City of Portland, Maine - Building or Use Permit Application

Permit No: 01-0803	Issue Date: JUL 16	CBL: 330 B015001
-----------------------	-----------------------	---------------------

Proposed Project Description:  
Install a 27' Round Above Ground Swimming Pool with Surrounding Deck

BUILDING PERMIT REPORT

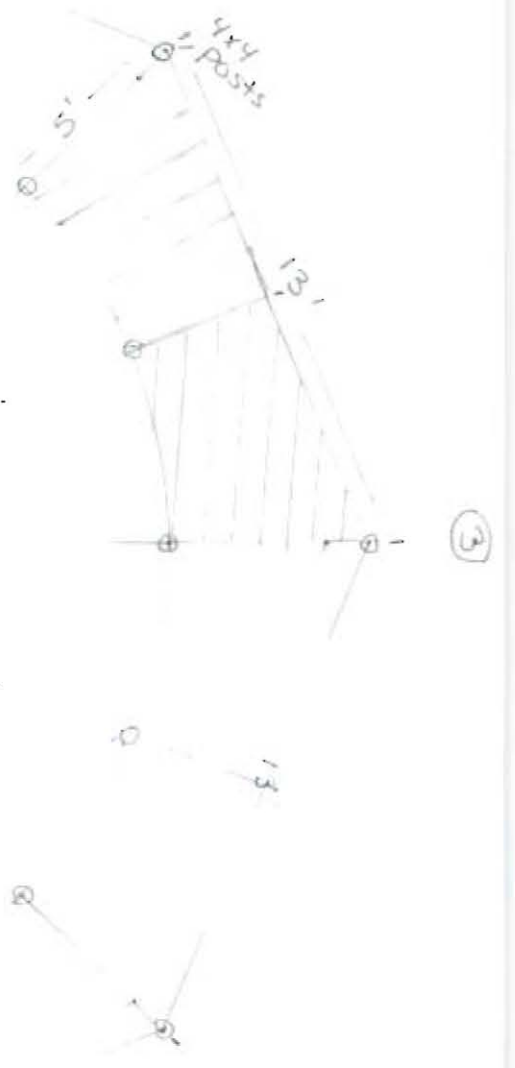
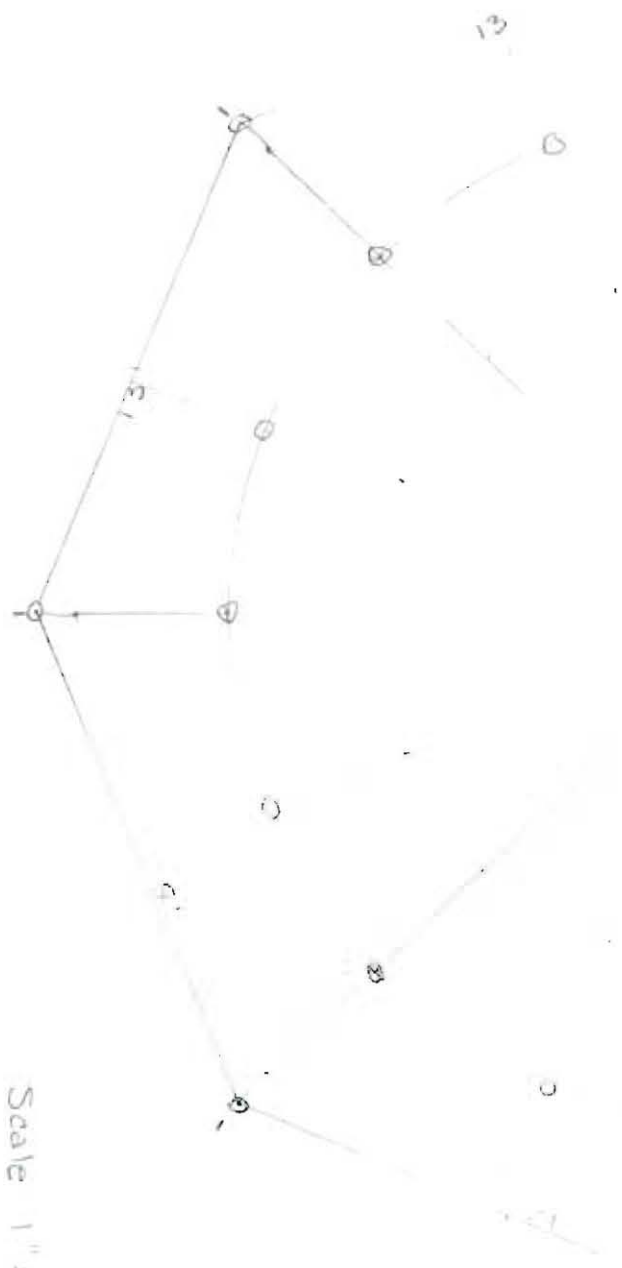
4/29/02 Pool ~~to~~<sup>deck</sup> up - Non Compliant

- ① Pool wall (barrier) height ranges from 37" to 49" - fencing around yard not complete  
No alarm or proper latch on door from house to deck.
- ② No Guard rail or handrail from upper to lower deck (exceeds 30" in height)
- ③ Stairs from upper to lower deck -  
Treads range from 9 1/2" to 11" with nosing from 0 to 1/2"

N.O.V. Sent 5/7 Re 4h
